RE: NCSF#1

Re: **Site Development Plan Approval Application**
North Castle South Fire District No. 1
621 North Broadway
Section 122.20, Block 1, Lots 5, 6, 7

An annotated response to Kellard Sessions memo dated May 22, 2020 is provided below in red. Comments addressed by others are provided separately.

The following is an annotated response to Kellard Sessions memo dated May 22, 2020. Response noted in red, Comments addressed by others provided separately.

SHEET A-102

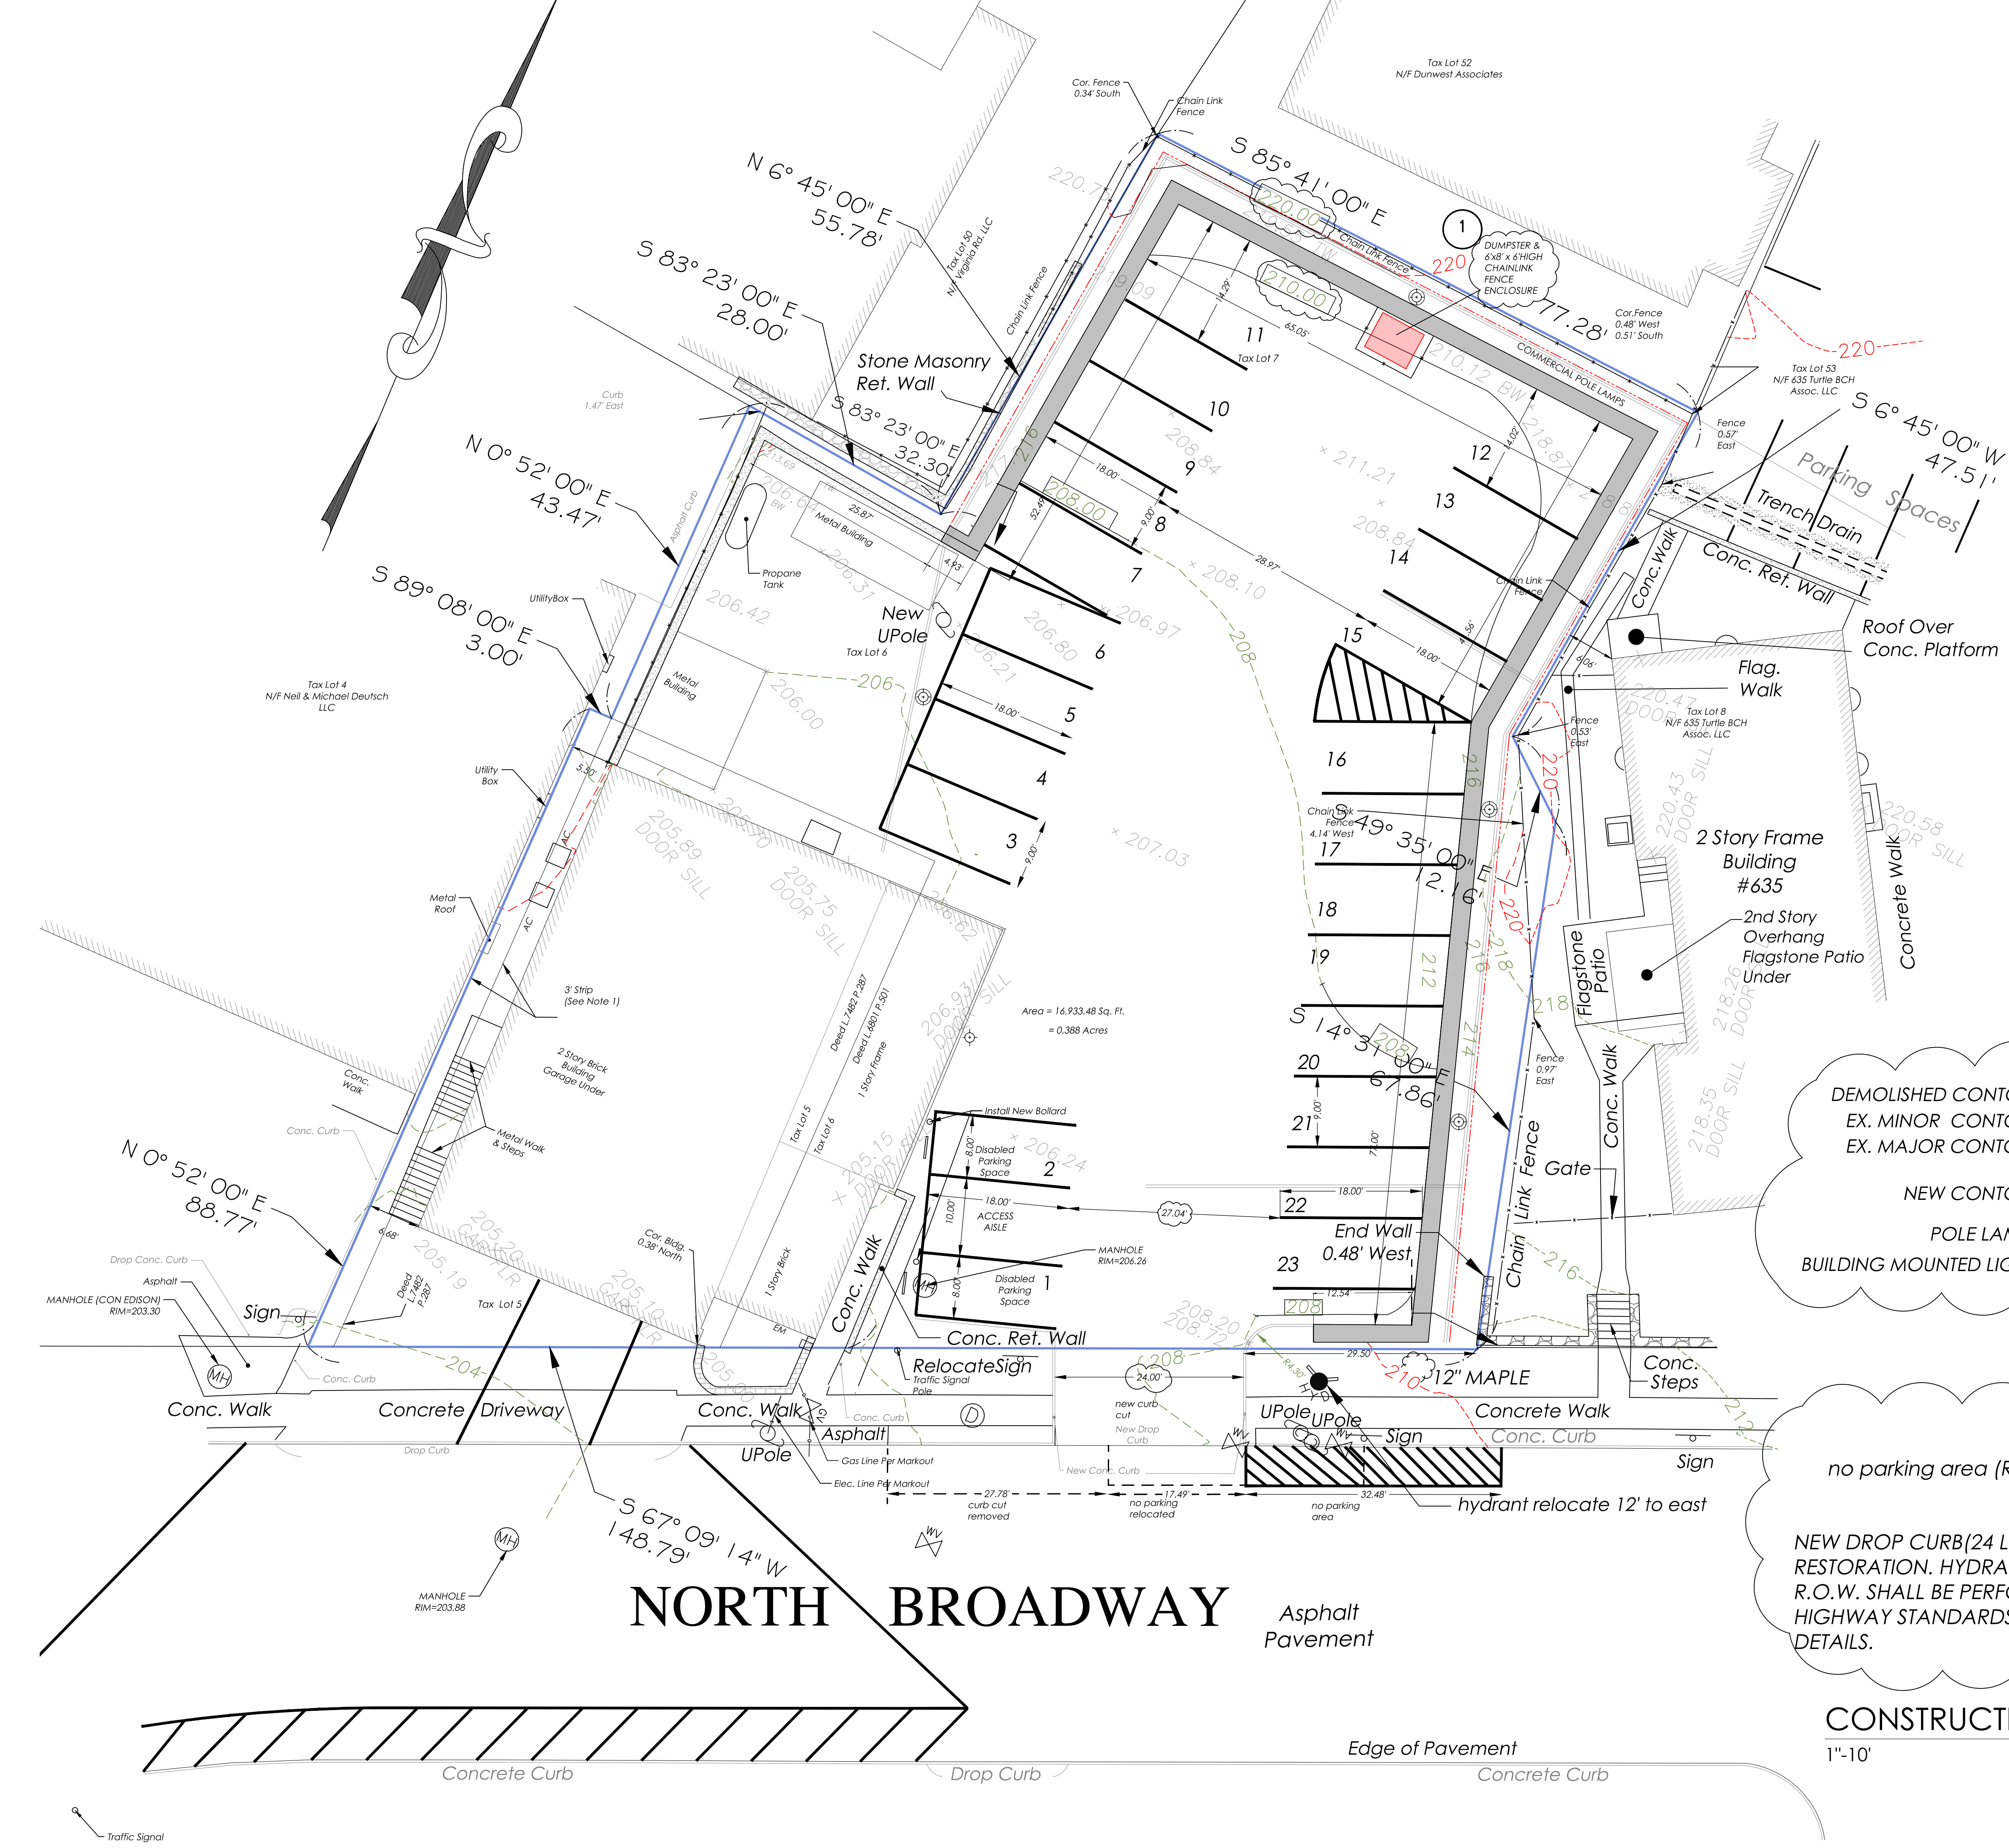
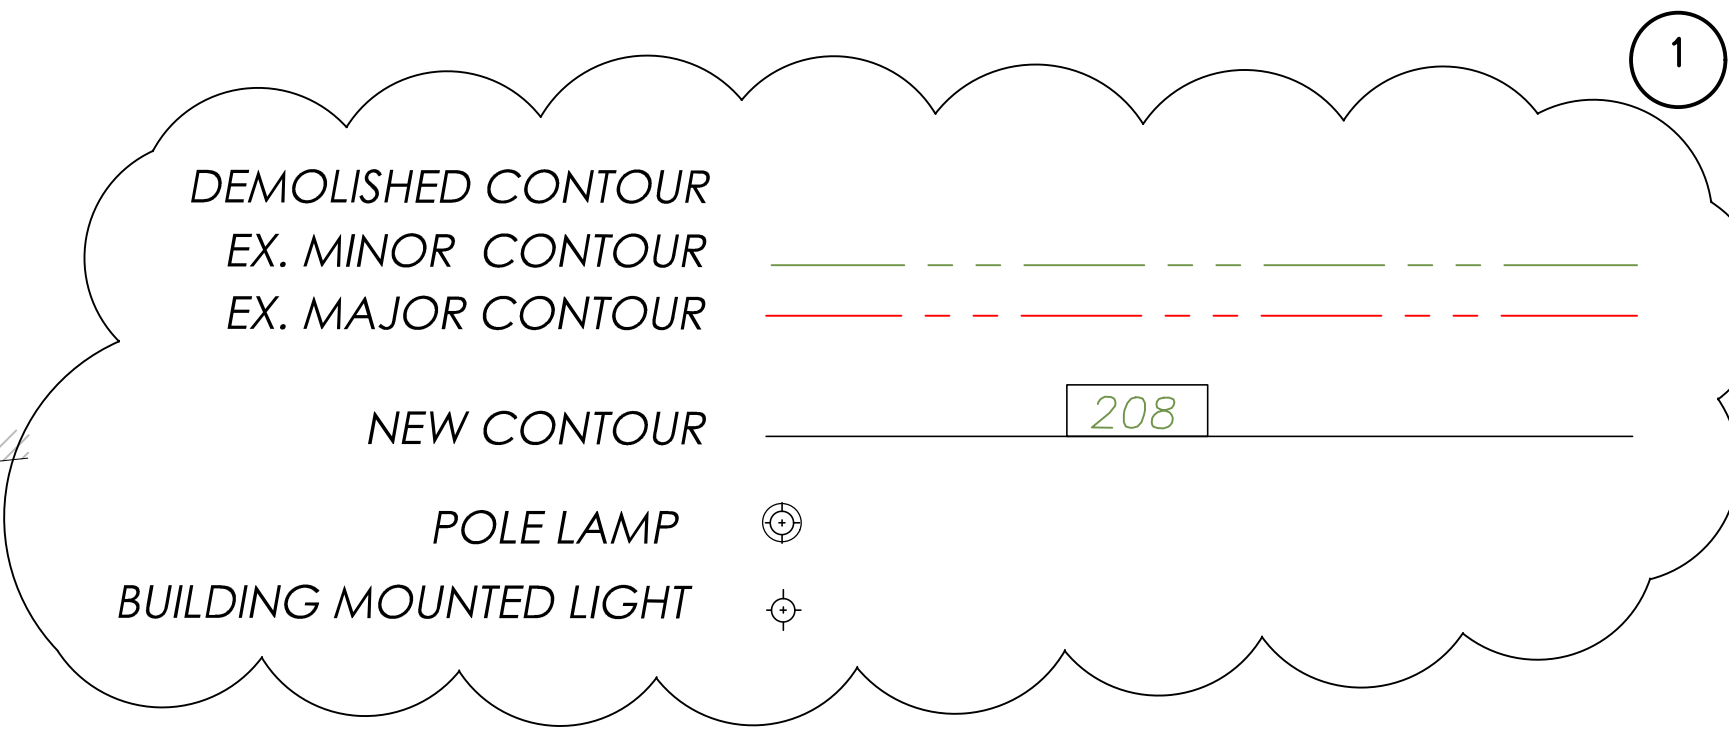
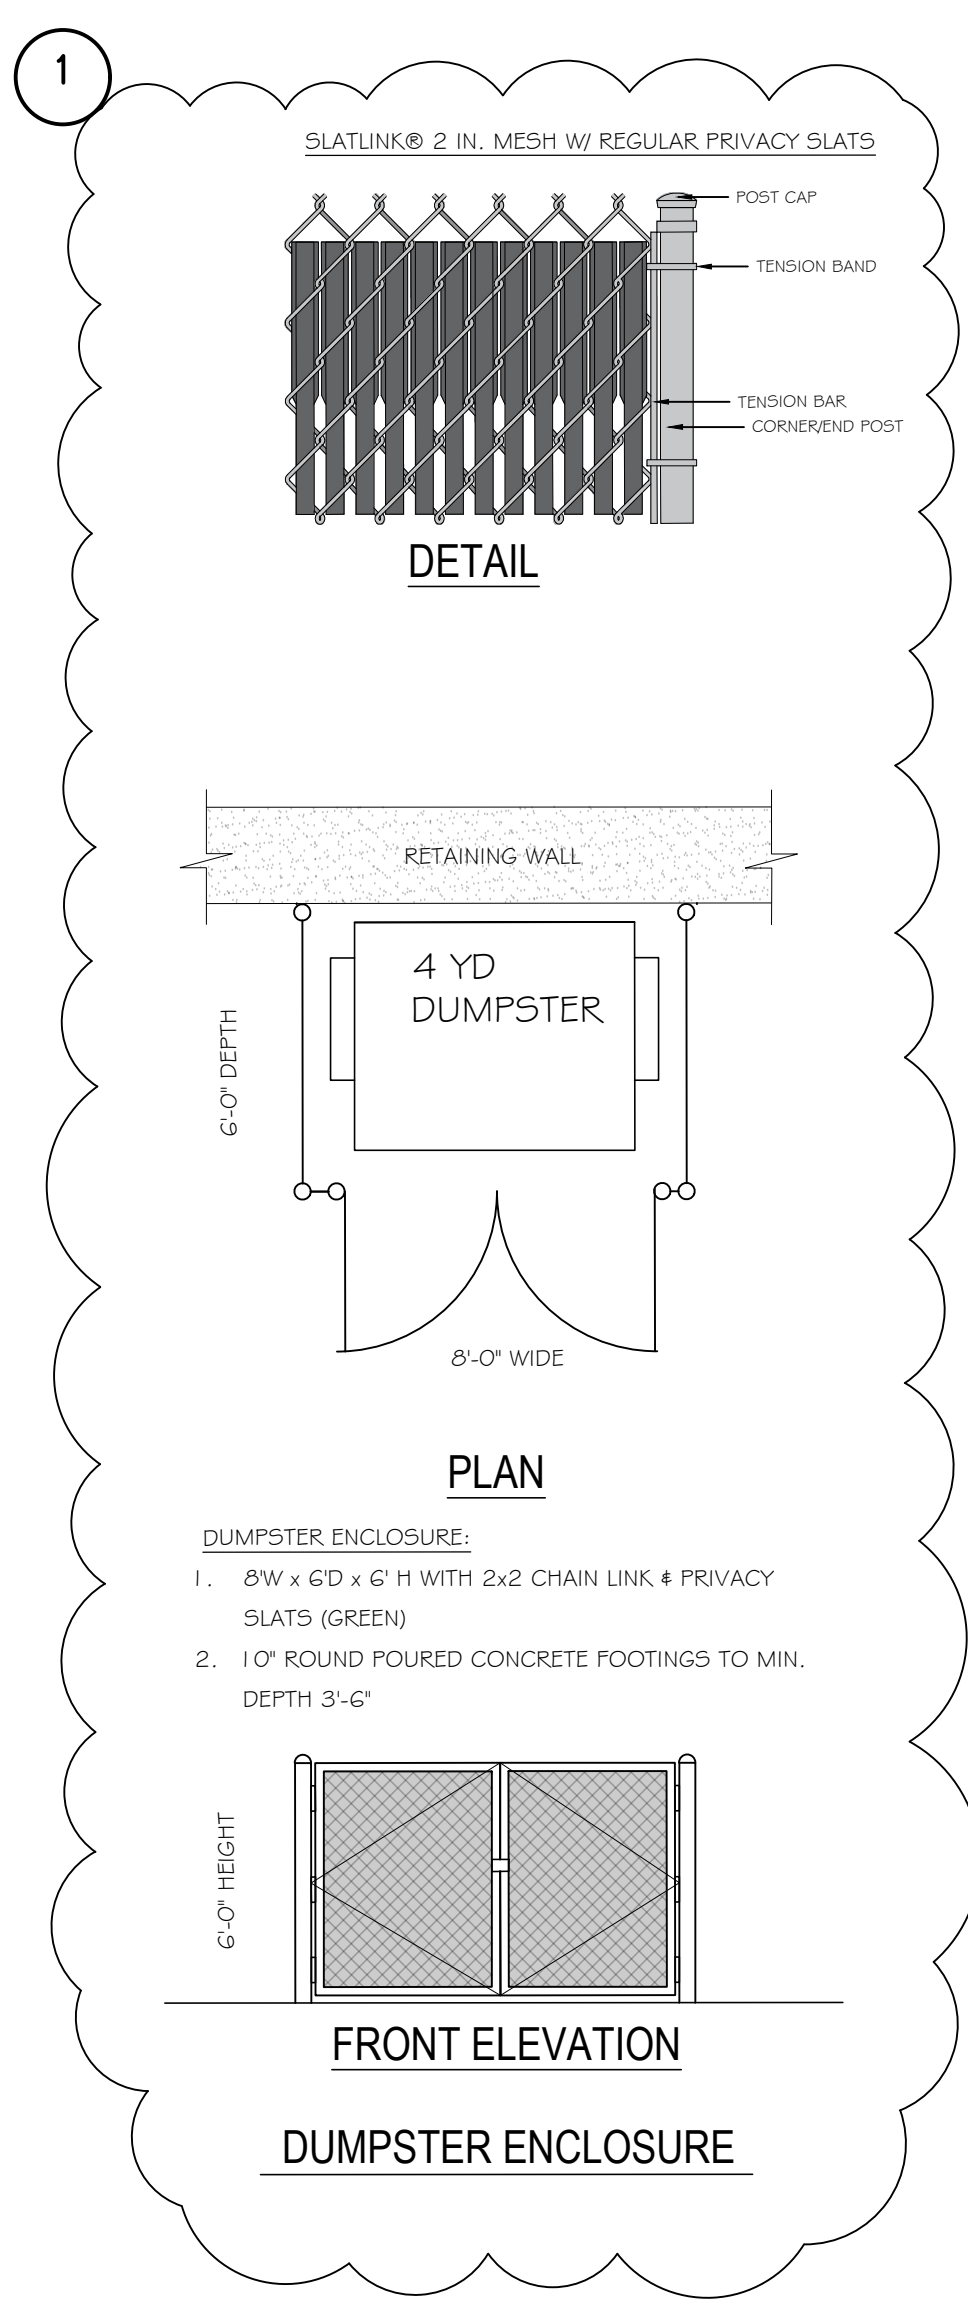
2. The Site Plan proposes an access drive with a width of 20 feet. However, as required by Section 355-56 G of the Town Code, access drives serving parking facilities with 21 spaces or more require access drive with of 24 feet. The plan should be revised to accommodate this.

3. The plan proposes shifting the existing driveway access approximately twelve (12) feet to the east, requiring the relocation of an existing fire hydrant and the loss of one on-street parking space. The reduction in on-street parking and required revised signage should be reviewed by the Highway Department and may require approval by the Town Board. The plan should clearly illustrate the limits of removals of existing curb and sidewalk and provide details for new sidewalk, pavement restoration and hydrant relocation.

4. The plan proposes modifications to the driveway access onto North Broadway (NYS Route 22). The applicant will be required to obtain driveway access permits from the New York State Department of Transportation (NYSDOT).

PLANS HAVE BEEN ADJUSTED TO REFLECT THE NEW 24 FOOT WIDTH.

NEW DROP CURB(24 LF) WITH NEW SIDEWALK, AND PAVEMENT RESTORATION. HYDRANT RELOCATION. ALL WORK WITHIN TOWN R.O.W. SHALL BE PERFORMED IN ACCORDANCE WITH TOWN HIGHWAY STANDARDS. NYSDOT PERMITS SHALL BE OBTAINED. SEE DETAILS.
